Santa Barbara County Planning and Development Department

DATE: November 8, 2006

RE: CEQA Determination: Finding that CEQA section 15164 (Addendum) applies to the

Tajiguas Landfill Expansion Elimination of the Coastal Zone Southeast Corner Modification and Change in North Borrow/Stockpile Area. CEQA section 15164 allows an addendum to be prepared when only minor technical changes or changes which do not create new significant impacts would result. The Final Environmental Impact Report (01-EIR-05), prepared for the Tajiguas Landfill Expansion Project, is hereby amended by this section

Figure 2 - Revised Project Description Elements

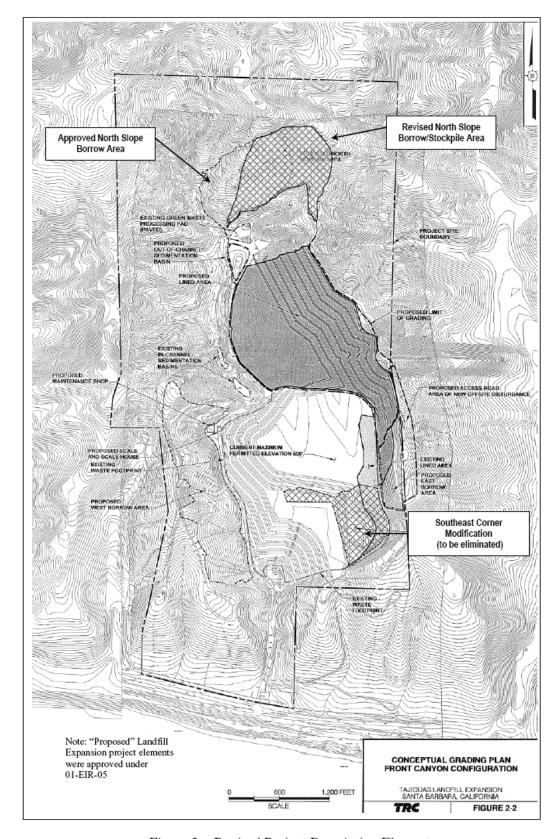
As a part of the proposed Tajiguas Landfill Expansion Project, a modification (Figure 2) was proposed to the southeast corner of the existing landfill. The modification involves excavation and relocation of waste and cover soil within and adjacent to the Coastal Zone above an elevation of 400 feet above mean sea level to another portion of the landfill. The Southeast Corner Modification was originally proposed to address a perceived inconsistency with the Coastal Act and Coastal Zoning Ordinance with respect to the permitted height of landfill activities within the Coastal Zone. At the time of the certification of the EIR it was believed that a prior permit (specifically the 1978 Solid Waste Facility Permit [SWFP]) issued for the Tajiguas Landfill set a vertical elevation limit of 400 feet above mean sea level (MSL) within the Coastal Zone⁴. Based on further review of relevant documents conducted subsequent to the certification of 01-EIR-05, the 400 foot limit appears to be spurious and is based on a misreading of the 1978 SWFP. However, the 2003 SWFP references the southeast corner modification, and thus contemplates excavating the municipal solid waste as described in the Final EIR.

RRWMD is proposing to begin planning for phased closure of the Coastal Zone portion of the Tajiguas landfill⁵. Phased closure would involve placement of a soil cover (cap) over the existing landfill, reconstruction of the landfill gas collection system, drainage improvements, and revegetation. To facilitate phased closure, minimize impacts of closure activities, and to reduce closure costs, the Southeast Corner Modification would be eliminated from the Tajiguas Landfill Expansion Project project description and municipal solid waste deposited above 400 feet MSL in the Coastal Zone would be left in place as a part of the closure.

The proposed Tajiguas Landfill Expansion Project includes a ~19 acre north slope borrow/stockpile area. This borrow area has not yet been disturbed by landfill activities associated with the expansion. RRWMD is now proposing to modify the boundaries of the borrow area to accommodate temporary stockpiling of excess material excavated during the construction of the slopes for the landfill expansion area where a new leachate liner system is being installed. The reconfigured area provides slopes that are more suitable for the temporary stockpiling. The modified borrow area would include an area of ~19 acres (Figure 2) which overlaps but extends to the east of the currently approved borrow area. The borrow/stockpile area would be used for stockpiling material excavated from the landfill expansion area and would provide material for intermediate and final cover.
